AMENDMENTS TO THE DRAWINGS

REMARKS

Claims Rejections - 35 USC §112 First and Second Paragraphs

Fig. 9a

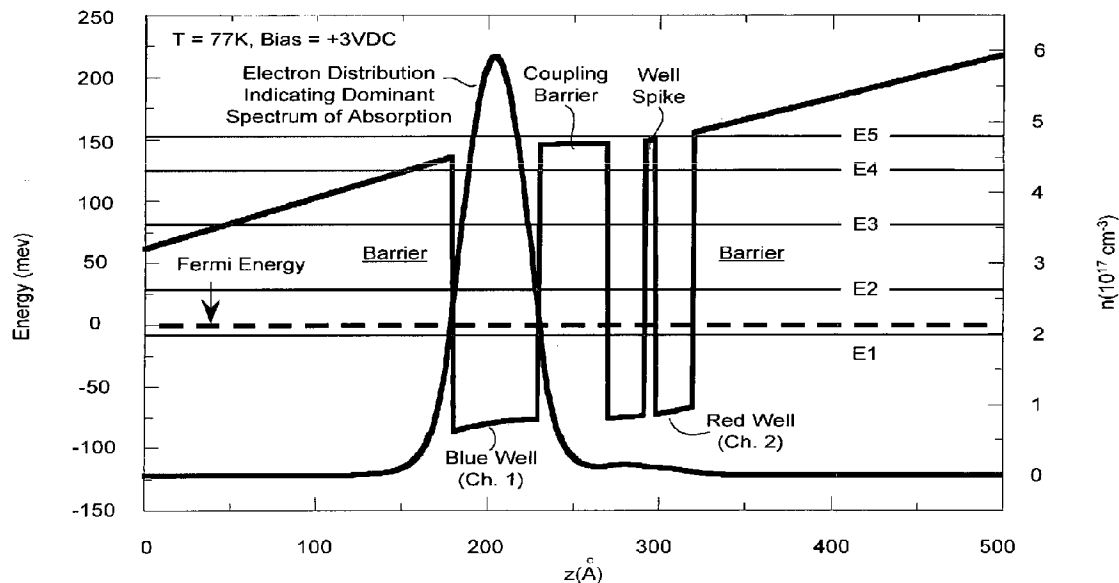
The Office states that “the device is not considered enabled because Fig.s 9a and 9b show energy levels continuous across all of the wells where absorptions apparently are equal across the entire device, i.e. there is no apparent distinction between the well absorptions. The wells

appear to be able to absorb the exact same photon energies. Also the Fermi energy is straight across the the device whereas there is supposedly a bias across the device. The energy levels across the device also apparently show the wells to be “coupled” as a superlattice.” (Office Action dated 2/21/2007, page 2)

The Office also asks for clarification as to the operation of the well spike. And in particular, how the well spike affects only the ground state energy and not the excited state energy.

The Office also requests further details concerning how the well spike adjusts the ground state without affecting the upper energy levels. The operation is based upon the well known first-order perturbation theory in quantum mechanics. This theory states that the energy (E) of a state is perturbed by a certain amount (DE) in response to a potential perturbation (V), where $DE = \langle s|V|s^* \rangle$, where s is the state wavefunction and s^* is its complex conjugate. Expanding, $DE = \text{integral} \{ s.V.s^* dz \}$ from $z = 0$ to infinity.

While the Applicant is not claiming a method for manufacturing, the "well spike" is a layer of material grown epitaxially in the middle of the quantum well layer as shown in Fig. 9a and 9b. An example is a layer of AlGaAs in the middle of a layer of GaAs wherein the AlGaAs is the "spike" layer and the GaAs is the quantum well layer. (see patent application Par [0067]) The "spike" is named as such because the potential energy for electrons (or holes) is higher in this layer than in the GaAs layers on either side of it. And the layer is designed to be very thin – for example, a fraction of a monolayer to one or two monolayers thick. The potential energy versus distance of this layer thus looks like a mathematical "delta" function, hence the name "spike". The term "well spike" is used because the spike is in the middle of the potential well (the well bottom being defined by the potential energy of the GaAs layer).

Thus the structure of the well spike and the entire quantum well structure is described according to one embodiment and comports with the drawings.

In the claimed device, the perturbation (V) is provided by the "spike" layer whose potential energy height is V. Even number states (2, 4, etc.) all have a null or zero in their wavefunctions (s and s^*) around the center of the quantum well, where the thin "spike" layer (which is V) is placed. $DE = 0$ for these states. That is, their energies are not perturbed.

Odd number states, on the other hand, have a maximum in their wavefunctions (s and s^*) around the center of the well. These states therefore experience a maximum energy shift given by (solving the above integral): $DE = V.m.m$, where V is the height of the potential spike, and m is the maximum value of the wavefunction (of course, $s = s^*$ for real wavefunctions such as these). This underlying principles for the quantum mechanics background information is available from numerous texts and treatises.

This is precisely one point of the claimed invention. **The ground state (state 1) of the quantum well with the well spike can be adjusted to experience a positive energy shift (for**

positive V), whereas the first excited state (state 2) experiences no energy shift. Higher energy states are of no relevance in this device.

As detailed herein, the well spike structure has been explained. The ‘means for adjusting’ the well spike is provided by an example in Par [0068] that explains how the biasing scheme operates in connection with Fig. 9a and 9b. Claims 3, 9, 10, 12, 19, and 20 also claim aspects related to the biasing scheme. As noted in Claim 9, “applying a first bias causes the first spectrum to be dominant and applying a second bias causes the second spectrum to be dominant.” The Band diagrams and Eigenstates presentation is familiar to those in the art and provides a useful manner of presentation. As shown in Fig.s 9a and 9b, with a change in the bias from +3Vdc to -3Vdc, the ground state changes but the upper energy levels are unaffected and continuous across the wells.

Fig. 9b

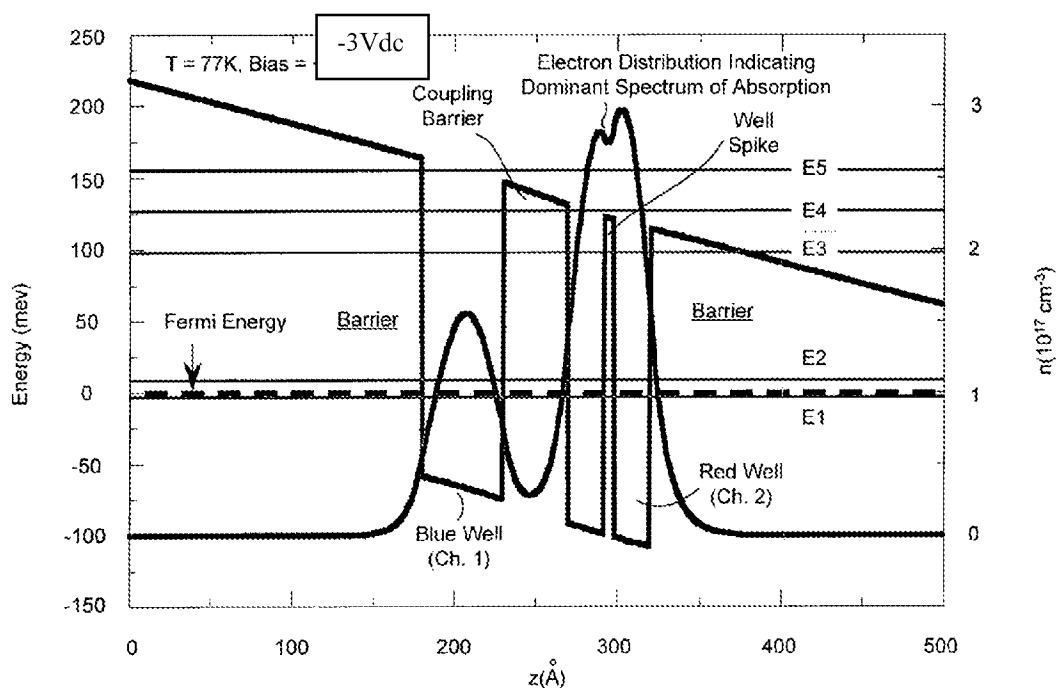
The attached sheet of drawings includes changes to Fig. 9b. This sheet replaces the original sheet including Fig. 9b. In Fig. 9b, the Bias was labeled as “+3VDC” and should be “-3VDC”.

The Office keenly noted that Fig. 9b had a bias labeled as “+3VDC” which should have been “-3VDC” as noted in the description. Fig. 9b has been amended accordingly and review and acceptance is requested to replace the drawing sheet. No changes are required in the specification. No new matter is added.
